CLERMONT COUNTY OHIO

PLANNING COMMISSION STAFF REPORT

BLUE HERON SUBDIVISION – DESIGN PLAN #650-2024

Re: Blue Heron Subdivision – Design Plan Review

TYPICAL STREET SECTION

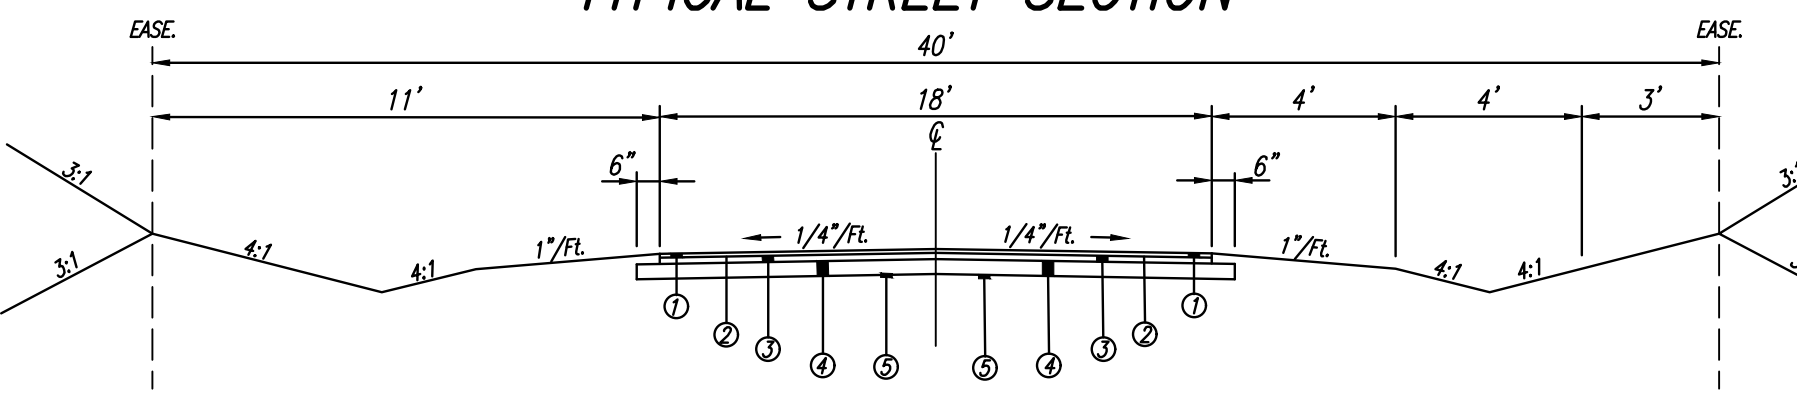
1. The Typical Street Section needs to be labeled "Typical Private Street" Section
2. The proposed pavement cross-section needs to be adjusted to match Clermont County Typical Sections.
3. The proposed Forty (40) Foot Ingress/Egress and Utility Easement needs to be labeled as a "Private Street and Utility Easement."

Job No.: 20-0309A C 100

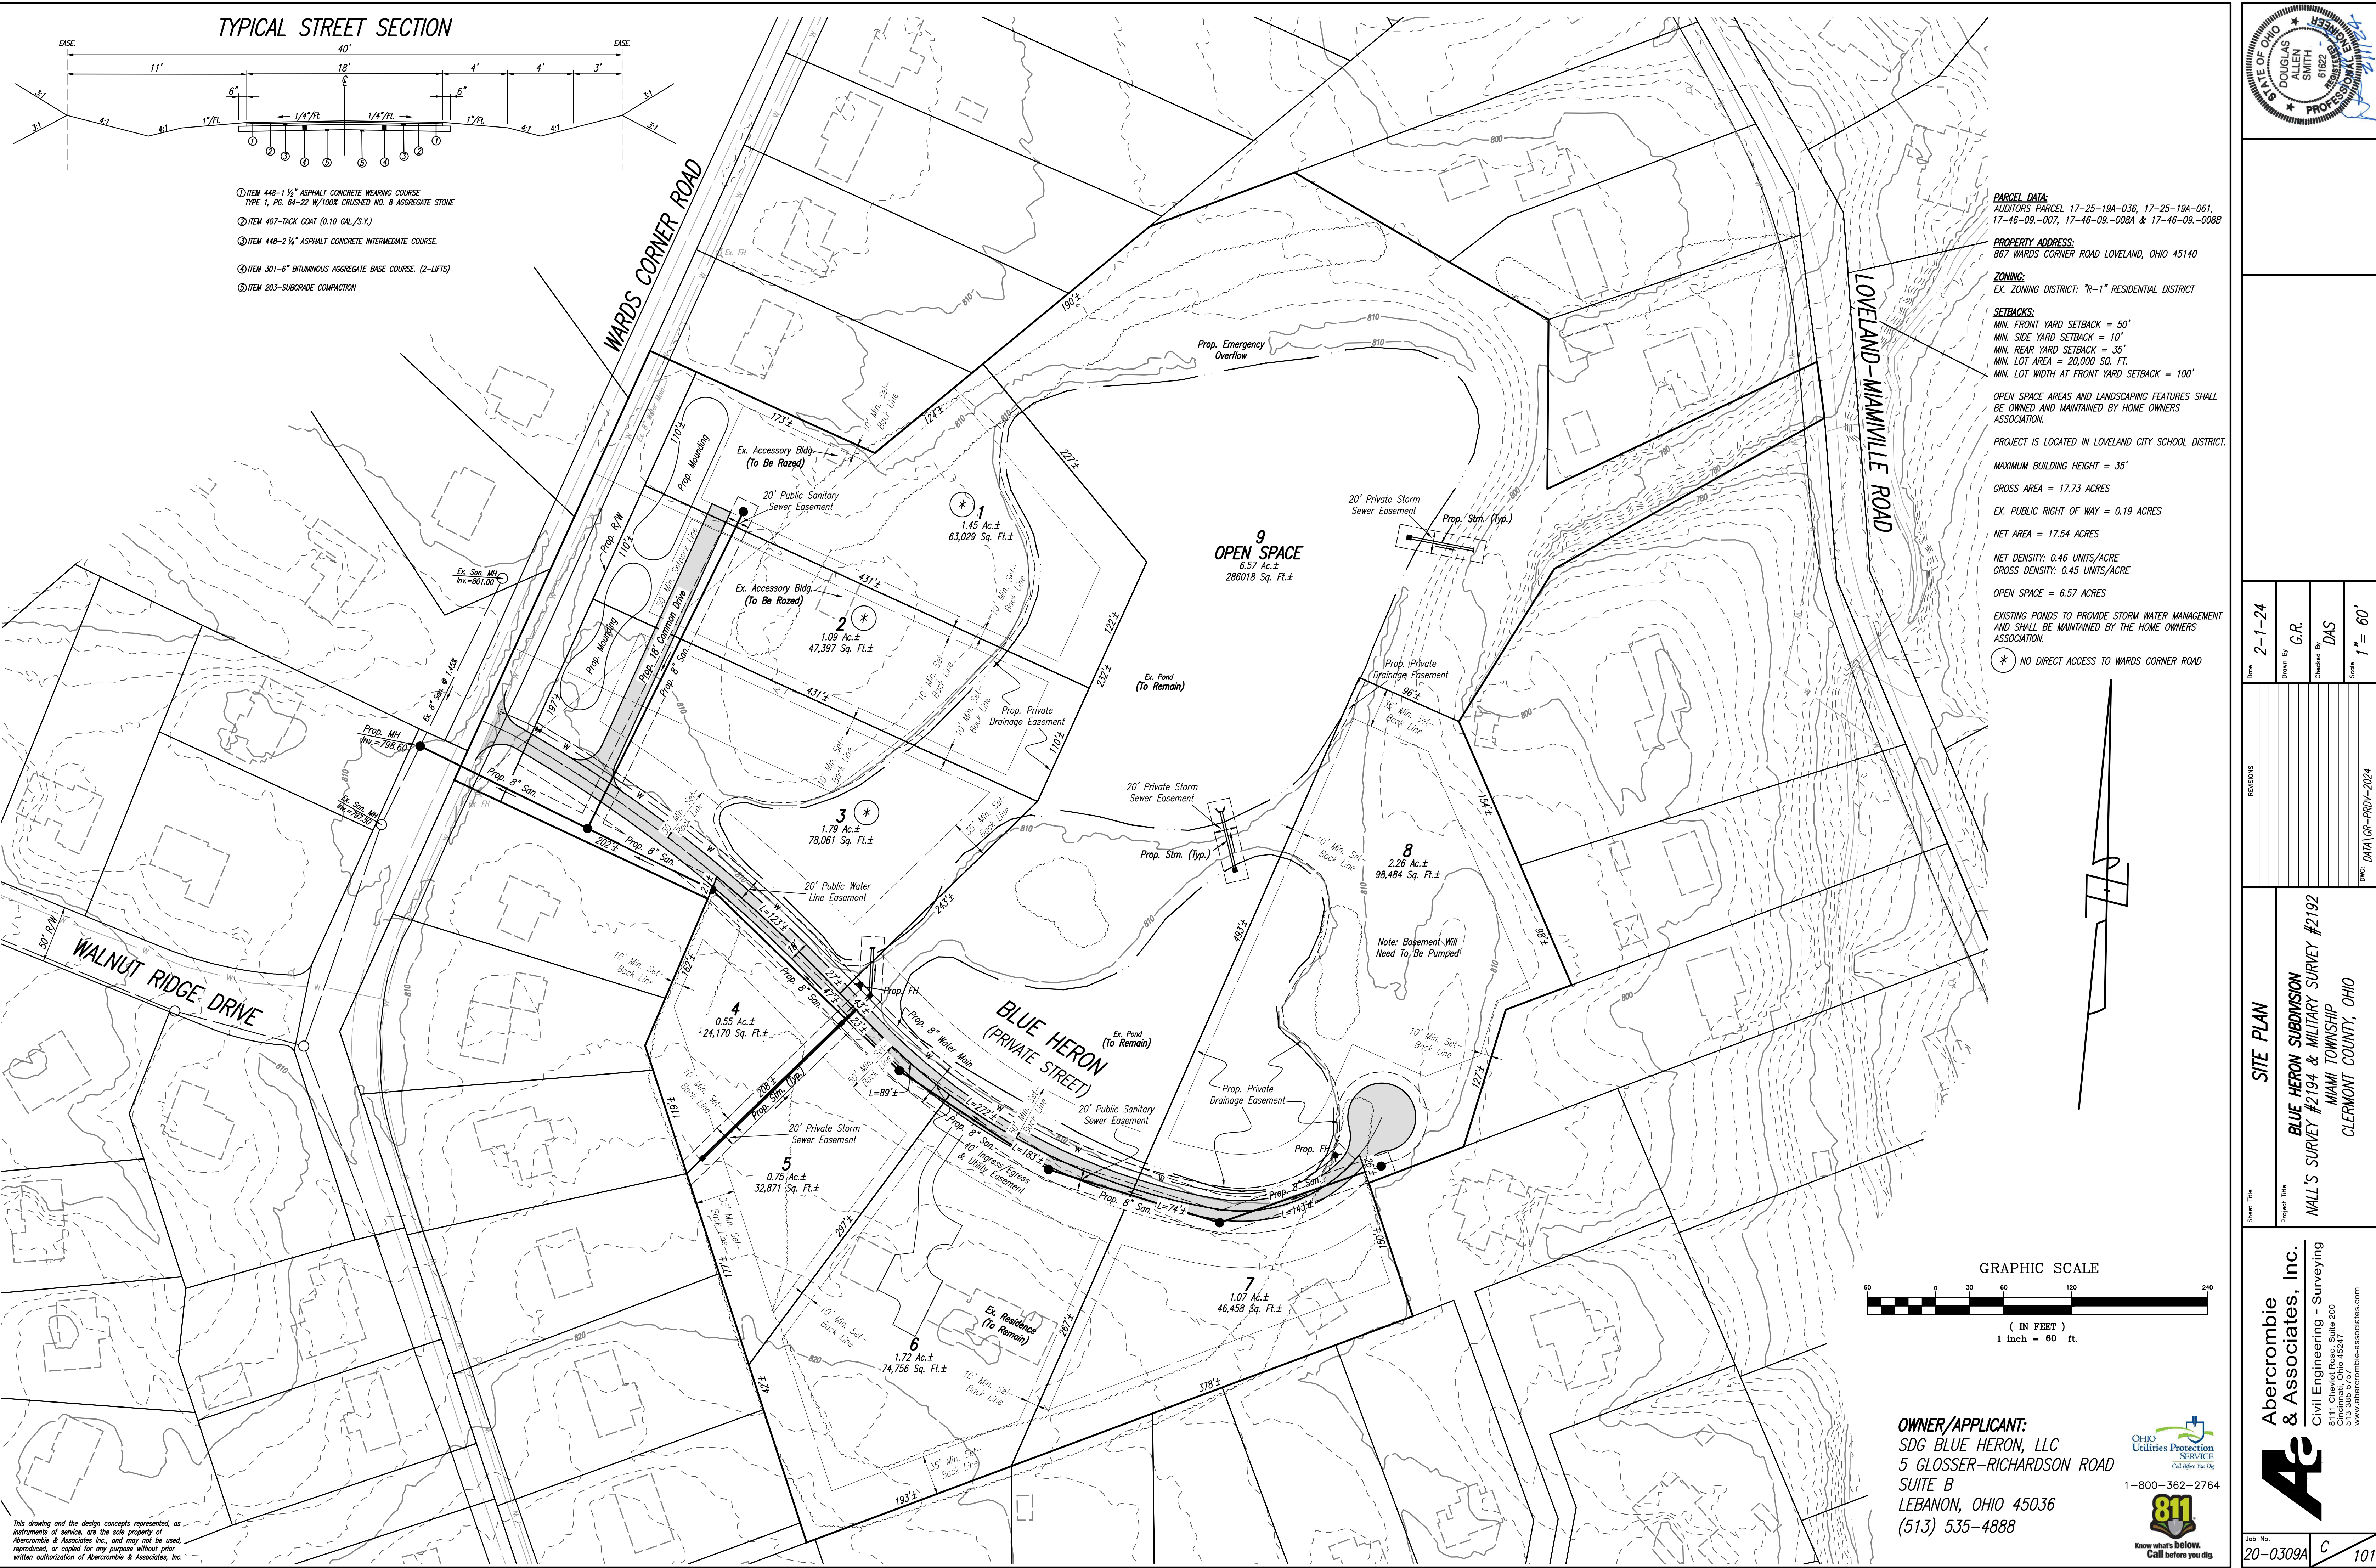
2. Indicate total acreage of land in lots, total acreage of land contained in streets, total acreage of open space, park land, etc.
3. Ensure naming of the private street labeled "Blue Heron".

4. Indicate proposed width of the private street on the plans.
5. Include verification that the proposed entrances meet all applicable Sight Distance requirements as established by the Clermont County Engineer.

6. Include the Drainage area of the project.
7. Label width of panhandle that abuts Loveland-Miamiville Road.
8. Include Open Space area ownership information per Article V Section 521.
